REQUEST FOR COUNCIL ACTION

AGENDA SECTION: PUBLIC HEARING	ORIGINATING DEPT: PLANNING	ITEM NO. E-4
ITEM DESCRIPTION: Type III, Phase III Incentive Development Final Plan #02-35 by Bethel Lutheran Church to permit a 33,515 square foot addition to the existing facility that would exceed the permitted floor area ratio. The property is located at 810 Third Avenue SE. The property is bounded by 3 rd Avenue SE on the west, 4 th Avenue SE on the east, 9 th Street SE on the south and 8 th Street SE on the north.		PREPARED BY: Theresa Fogarty, Planner

RE: Type III, Phase III Incentive Development Final Plan #02-35, by Bethel Lutheran Church to permit a 33,515 square foot addition to the existing facility that would exceed the permitted floor area ratio. The property is located at 810 Third Avenue SE. The property is bounded by 3rd Avenue SE on the west, 4th Avenue SE on the east, 9th Street SE on the south and 8th Street SE on the north.

RECEIVED
SEP - 5 2003
CONSTRUCTION DOCUMENTS
LANDSCAPE PLAN

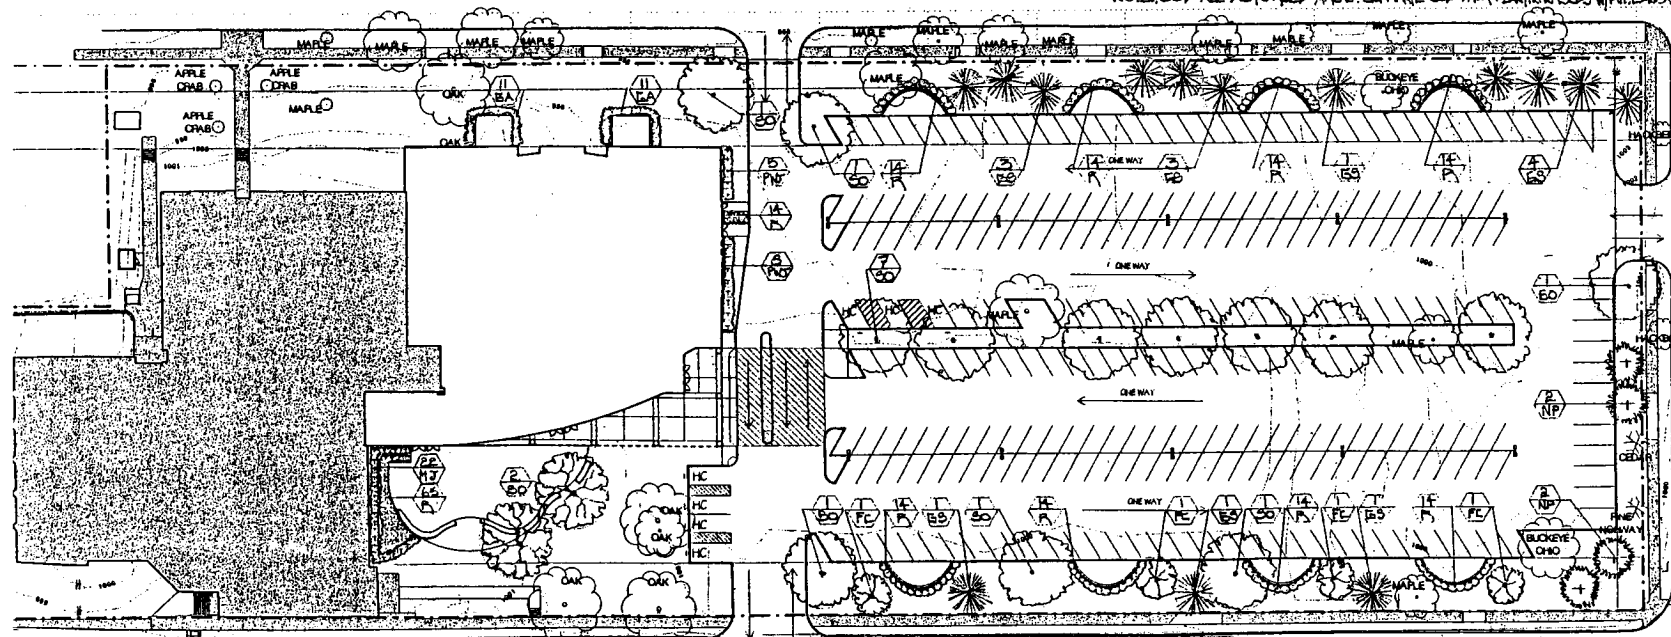
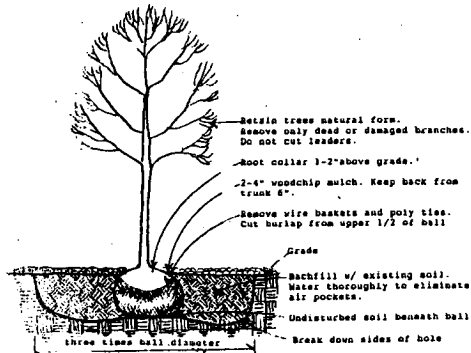
- ~~1. The design and site plan shall be revised, prior to the Council meeting to include the additional landscaping being provided from the preliminary plan and matching the number of parking spaces to be provided currently established at 262 spaces.~~

- e) **Foundation and Site Plantings:** *A landscape plan for the site has been prepared which indicates the finishes site will be consistent with the landscape character of the surrounding area. The retaining wall shown on the plan must be at least 18 inches from the edge of the sidewalk. In addition, the landscape plantings must also maintain 18 inches of clearance from the sidewalk at full growth.*

UTILITY PLAN

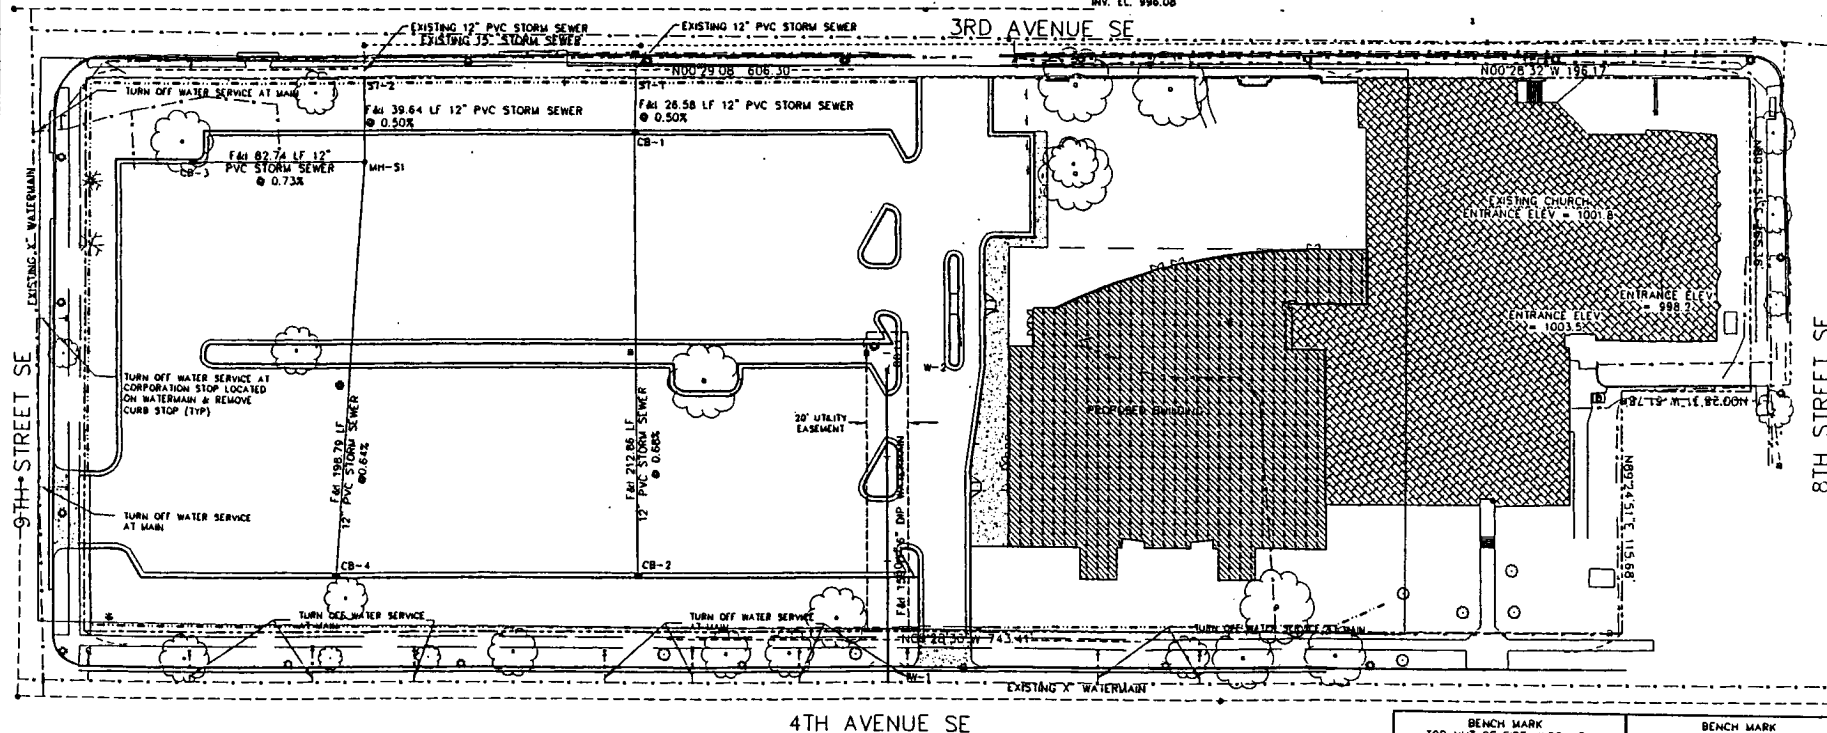
- 6. An additional fire hydrant shall be provided at the 4th Avenue SE entrance to the parking lot. The location of the additional fire hydrant can be moved to the boulevard area of 4th Avenue SE near the east entrance. The Fire Prevention Bureau has approved this location and since the hydrant will be located within the public right-of-way, the execution of a City/Owner Contract will be necessary.**

1 DETAIL AT PERIMETER RETAINING WALL
 A1.2 3/4" = 1'-0"

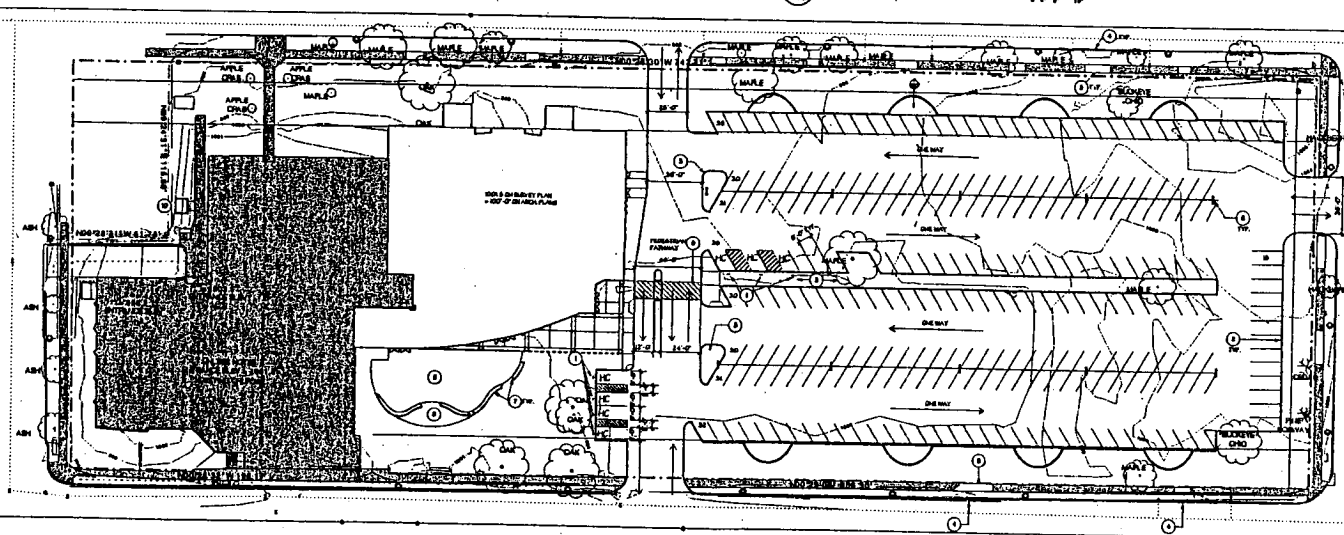
8. The retaining wall shown on the plan must be at least 18 inches from the edge of the sidewalk. Landscape plantings must also maintain 18 inches of clearance from the sidewalk at full growth.

6. The retaining wall shown on the plan must be at least 18 inches from the edge of the sidewalk. Landscape plantings must also maintain 18 inches of clearance from the sidewalk at full growth.

SITE PLAN

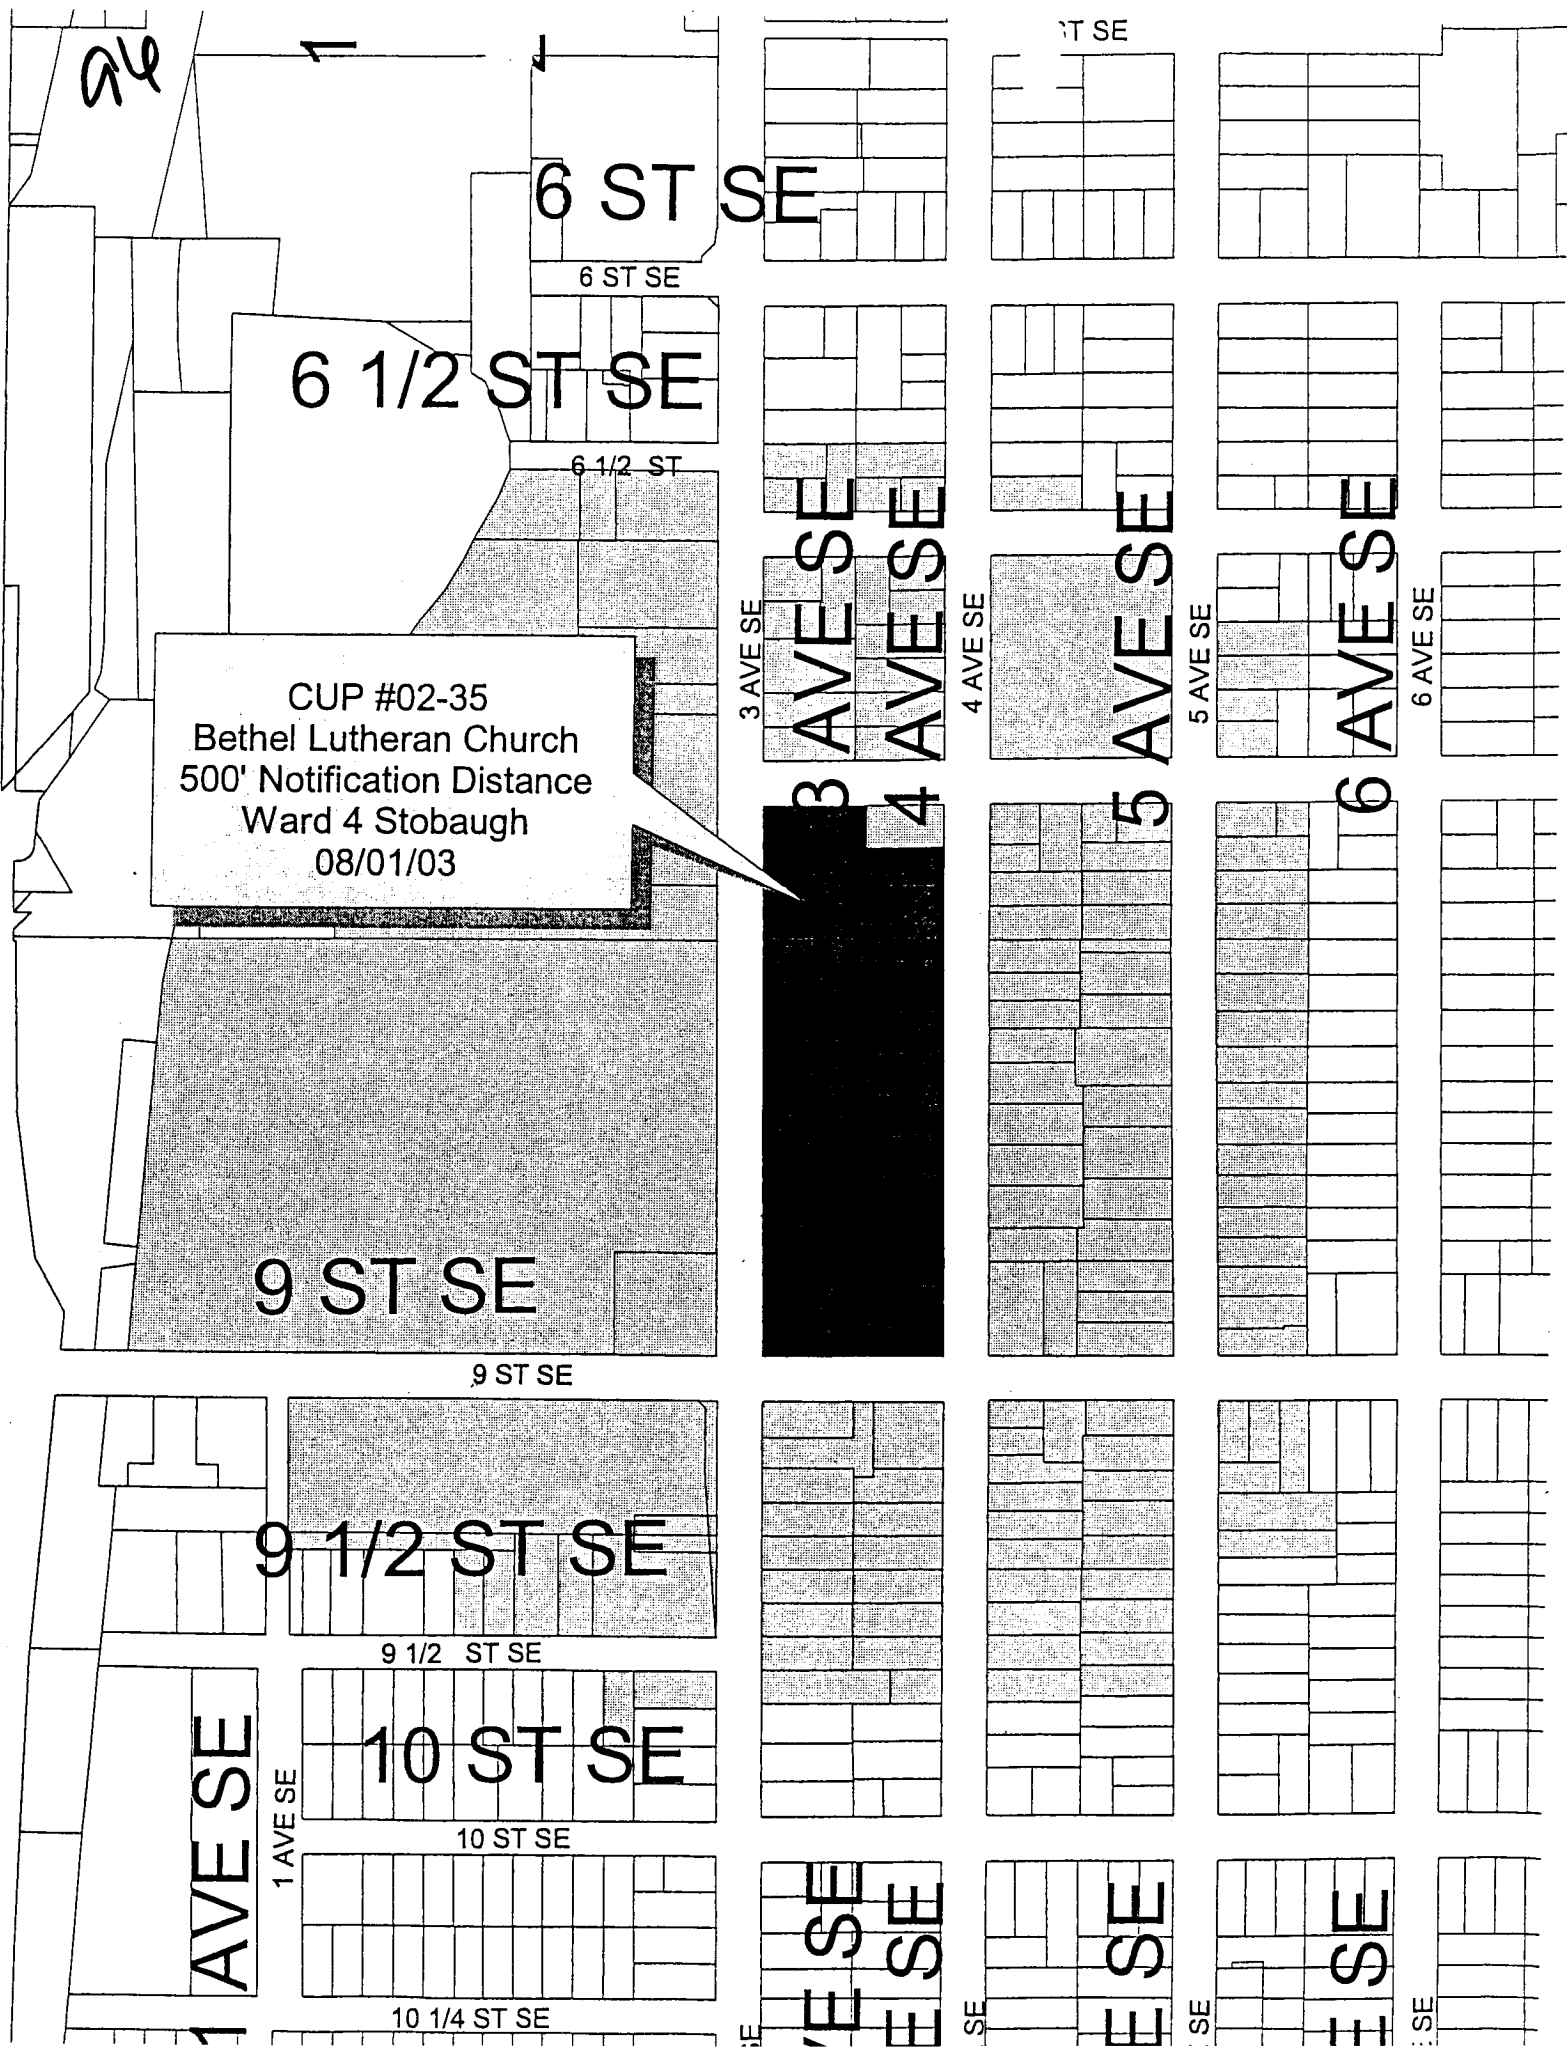
- 7. Council approval is required to allow the proposed access onto 3rd Avenue SE and onto 9th Street SE, since they exceed the maximum width allowed of 32 feet. Public Works supports the proposed access width at 36 feet. (Note: The widths are indicated as 36 feet on one page of the plans and as 37 feet on another). If the City Council doesn't approve the 36' wide access opening, the site plan shall be revised so that the openings are at a maximum 32' in width.**

- b) **Geologic Hazard:** *There are no known geologic hazards related to this project.*
- c) **Access Effect:** *The site plan shows a 36' wide access onto 3rd Avenue SE and onto 9th Street SE. Council approval is required to allowing, the proposed accesses to exceed the maximum width allowed of 32 feet. Rochester Public Works supports an access width at 36 feet. If the City Council does not approve the 36' wide access opening, the site plan shall be revised so that the openings are at the maximum 32' width.*

5. Council approval is required to allow the proposed access onto 3rd Ave SE, and onto 9th St SE, since they exceed the maximum width allowed of 32 feet (Note: The widths are indicated as 36 ft on one page of the plans, and as 37 ft on another). Public Works would support the proposed access widths at 36 ft max.

7. Council approval is required to allow the proposed access onto 3rd Avenue SE and onto 9th Street SE, since they exceed the maximum width allowed of 32 feet. Public Works supports the proposed access width at 36 feet. (Note: The widths are indicated as 36 feet on one page of the plans, and as 37th feet on another). If the City Council doesn't approve the 36' wide access opening, the site plan shall be revised so that the openings are at the maximum 32' in width.
